REPORT NO: SY-139R-77
AIRTASK NO: A5345341/0532/7534000001
WORK UNIT NO: A53411-20
DATE: 13 July 1977

COPY NO. 45 **NAVAL AIR TEST CENTER**
REPORT OF TEST RESULTS

Test and Evaluation of AH-1T Forward Ground Handling Gear Assembly (P/N 209-052-244-1);
Second Report (Final)

Figure 1
Forward Ground Handling Gear Assembly (P/N 209-052-244-1)

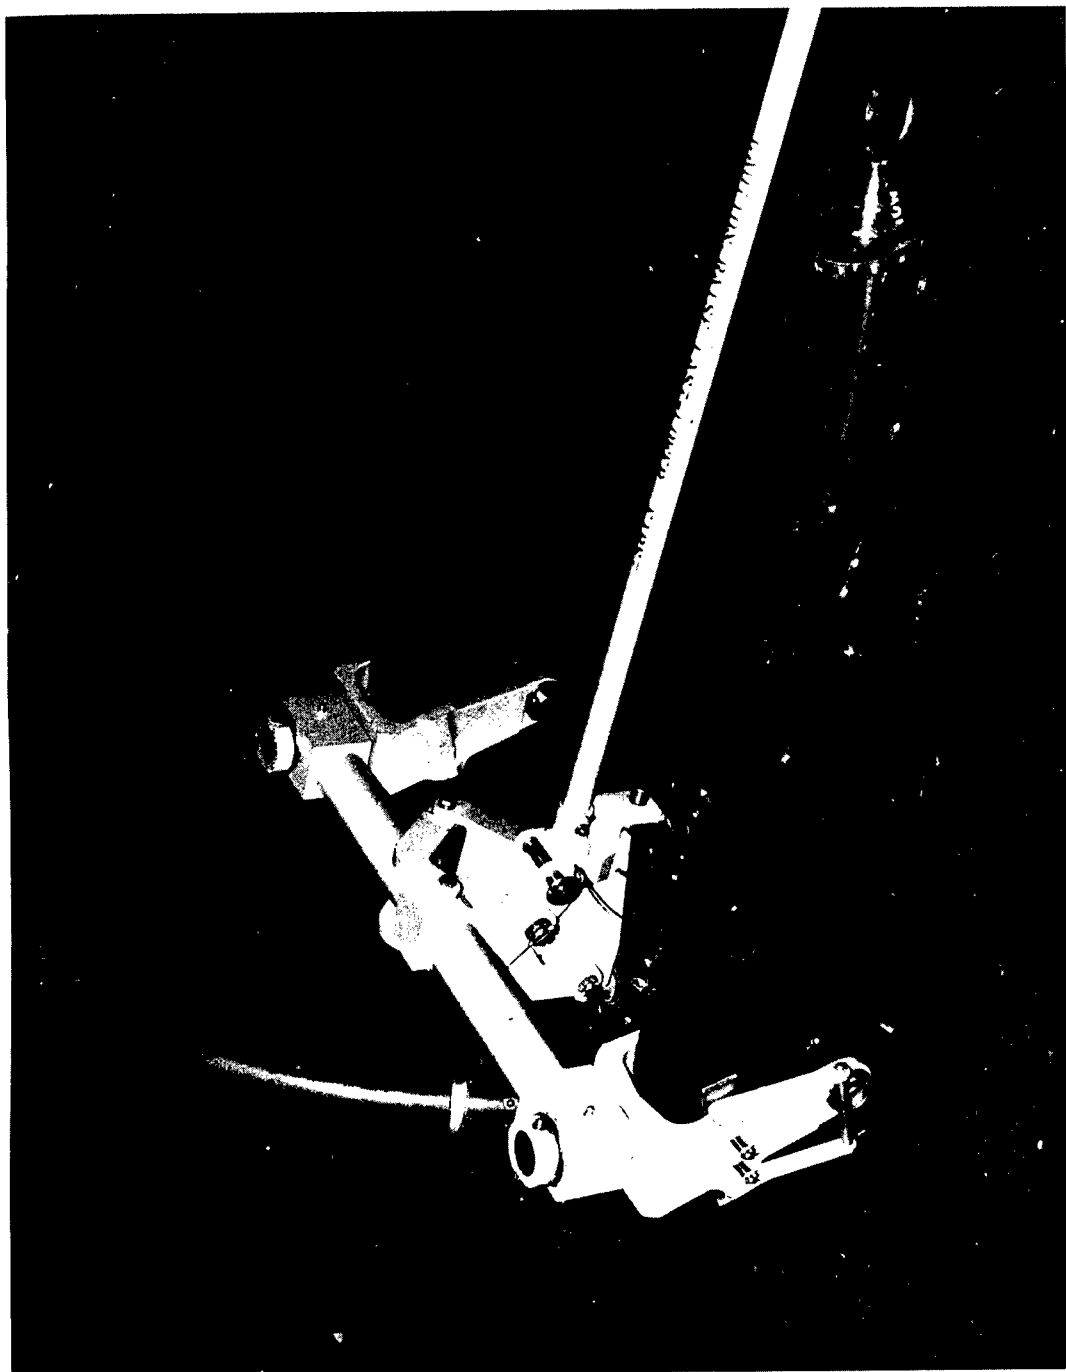
3. The Forward Ground Handling Gear Assembly (enclosure (1), figure 1) consists of two full castoring wheels connected by a common trunnion with a lift mechanism and a 36 in. (91.4 cm) lever handle. The Gear Assembly is attached to two lugs on the forward portion of each skid by means of a solid pin which engages the rear lug and a quick release pin that engages the front lug in the aircraft skid. The lever handle must be held straight up in a vertical position while installing the Gear Assembly, then rotated forward and down to the horizontal position to raise the front portion of the aircraft skid.

Figure 2
Brake Assembly

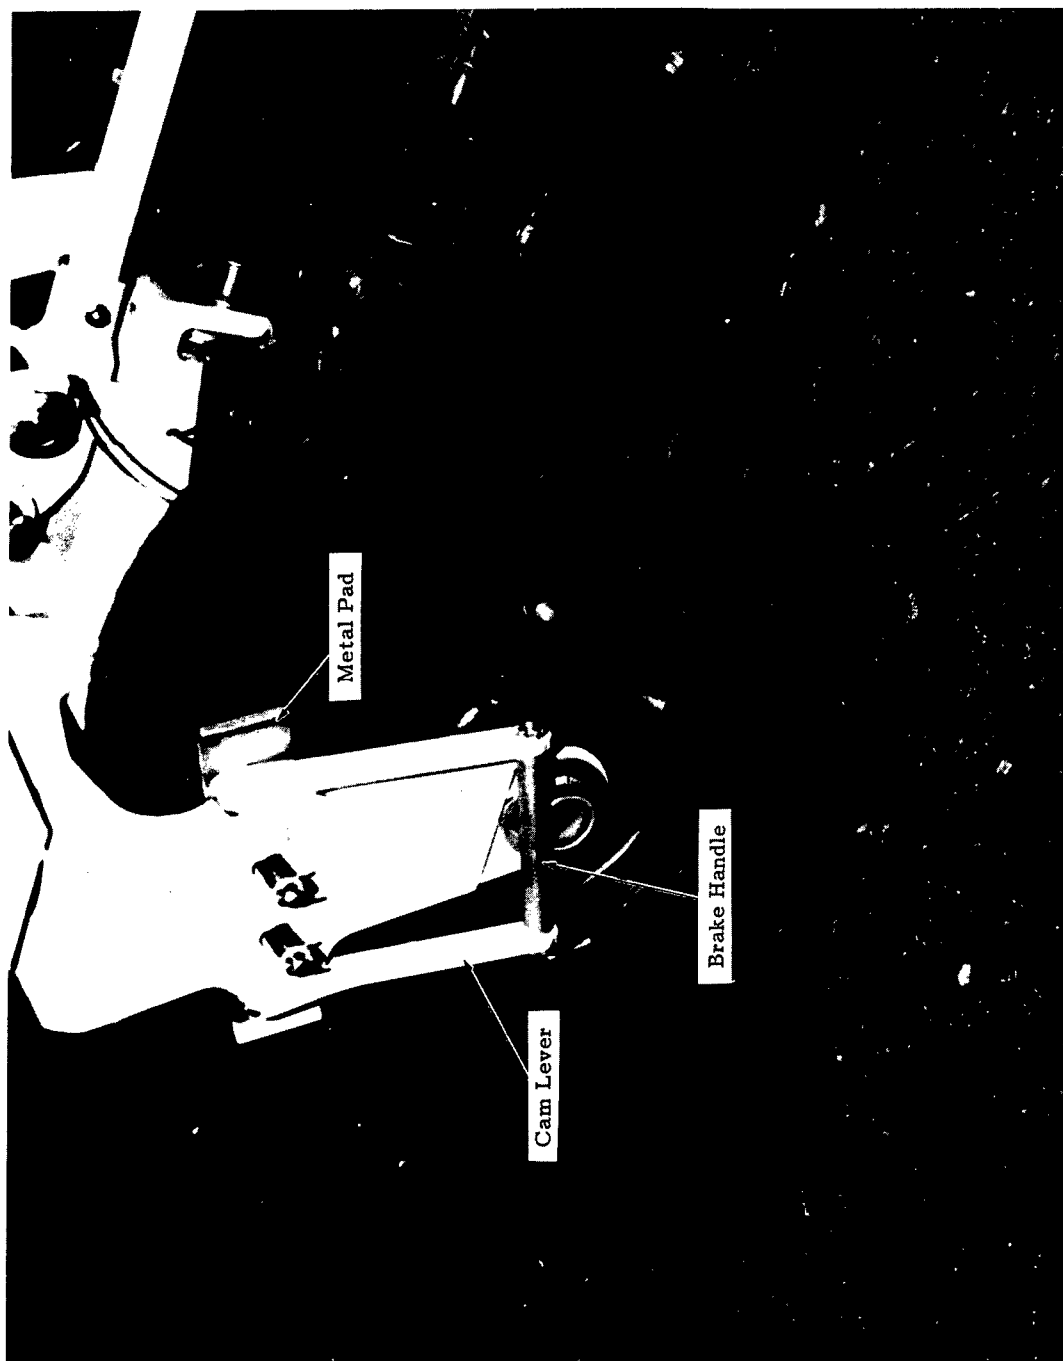
5. The means of stopping tire rotation are inadequate. The brake assembly consists of a cam-lever that contacts a metal pad which then presses against only one side of the pneumatic tire (enclosure (1), figure 2). Applying pressure to only one side of the tire causes tire deflection but does not prevent tire rotation. In addition, there is only one brake on each Gear Assembly which is located on the side of a caster housing. When the aircraft is being moved in one direction, the brake assembly is outboard of the tire. However, when the direction is reversed, the castered wheel rotates 180 deg placing the brake assembly on the inboard side of the tire. This type of brake assembly will result in maintenance personnel not being able to stop the aircraft in an emergency situation. The inadequate means of stopping tire rotation is a Part I deficiency which must be corrected as soon as possible.

6. There is a lack of provisions to prevent the brake assembly handle from being rotated 180 deg through the horizontal position. While the brake is off, the handle is in a vertical down position (enclosure (1), figure 2). To engage the brake, the handle must be pulled up to a horizontal position. Continuing to pull the handle up over center will place it in a vertical up position and will disengage the brake. In the up position, the handle will rest against the upper support of the wheel assembly (enclosure (1) figure 3). Maintenance personnel applying the brake and

14. Inadequate means of stopping tire rotation (paragraph 5).

15. Lack of provisions to prevent the brake assembly handle from being rotated 180 deg through the horizontal position (paragraph 6).

Figure 5
Inserting Quick Release Pin in Gear Assembly Housing

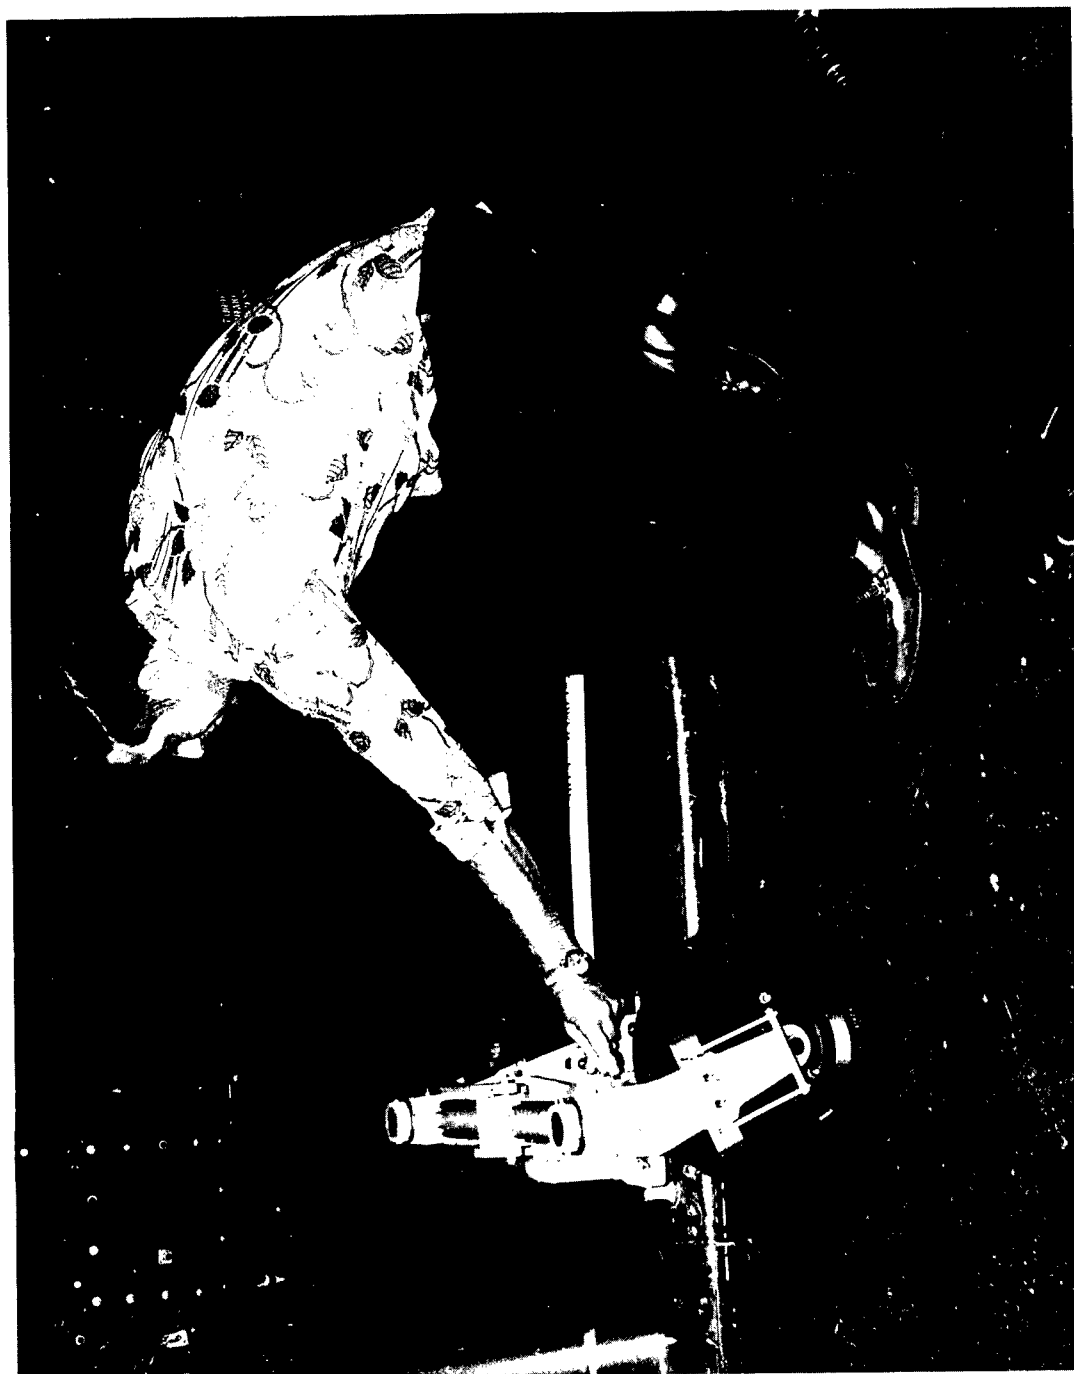
8. The shoulder bushings, in the housing where the quick release pin for securing the lever handle in the down position is inserted in the Gear Assembly, are incorrectly installed and of insufficient length. The two bushings are installed with the shoulders inboard and do not extend to the outer surface of the housings (enclosure (1), figure 6). This results in the quick release pin jamming in the housing. Also, the bushing could be pulled out of the housing by the quick release pin which would result in an abrupt raising of the lever handle and dropping of the aircraft skid. The incorrectly installed and insufficient length of the shoulder bushings constitutes a Part II deficiency which should be corrected as soon as practicable.

9. The length of the wire rope assemblies that secure the two quick release pins to the Gear Assembly is excessive. One quick release pin is used for securing the Gear Assembly to the aircraft skid front lug and the other quick release pin is used for securing the lever handle in the down position (enclosure (1), figure 6). These pins are different lengths and if interchanged will not function satisfactorily. The length of the wire rope assemblies allow either pin to be used for either application which results in a "MURPHY" situation. Also, the quick release pin could be damaged as a result of being caught under the skid while lowering the aircraft. The excessive length of the wire rope assemblies constitutes a Part II deficiency which should be corrected as soon as practicable.

17. Incorrect installation and insufficient length of quick release pin shoulder bushings (paragraph 8).

18. Excessive length of quick release pin wire rope assemblies (paragraph 9).

Figure 6
Quick Release Pin Housing

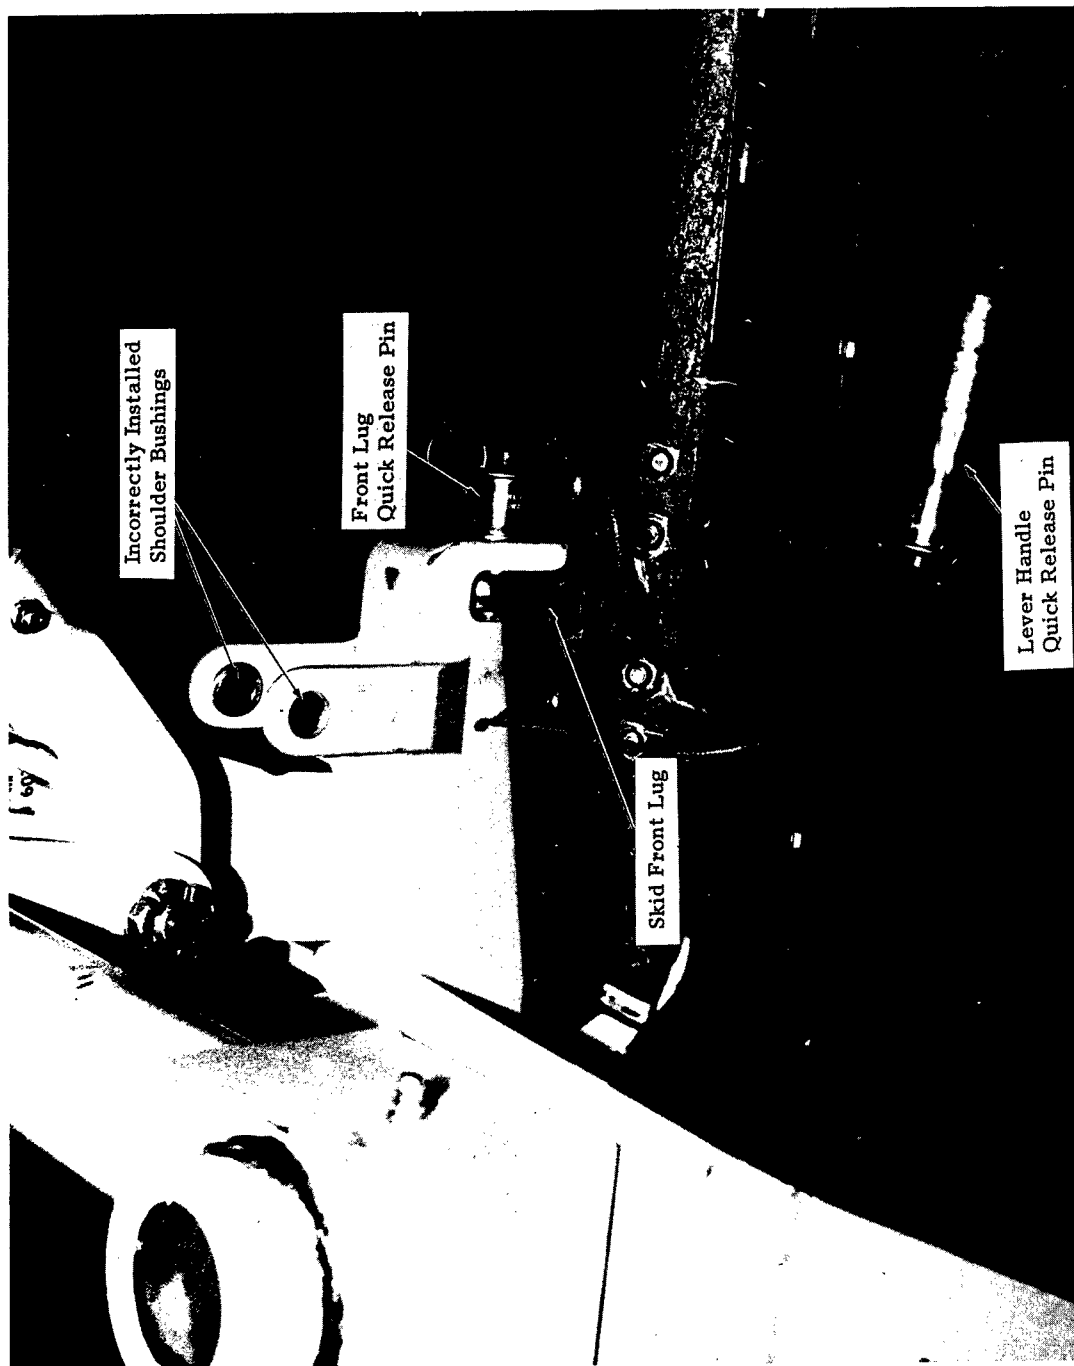
10. There is a lack of support for both ends of quick release pin. The forward attachment point for securing the Gear Assembly to the aircraft skid (enclosure (1), figure 6) consists of a bushed hole in the gear housing. A quick release pin is inserted through the bushed hole and a hole in the aircraft skid front lug. The aircraft weight is exerted on the quick release pin which is not supported at both ends and results in a bending moment being applied to the quick release pin. Failure to support the quick release pin at both ends so that a shear load is applied to the pin will cause excessive bushing wear and pin deformation which will result in the inability to secure the wheel assembly to the aircraft. The lack of support for both ends of the quick release pin is a Part II deficiency which should be corrected as soon as practicable.

19. Lack of support for both ends of the forward attachment point quick release pin (paragraph 10).
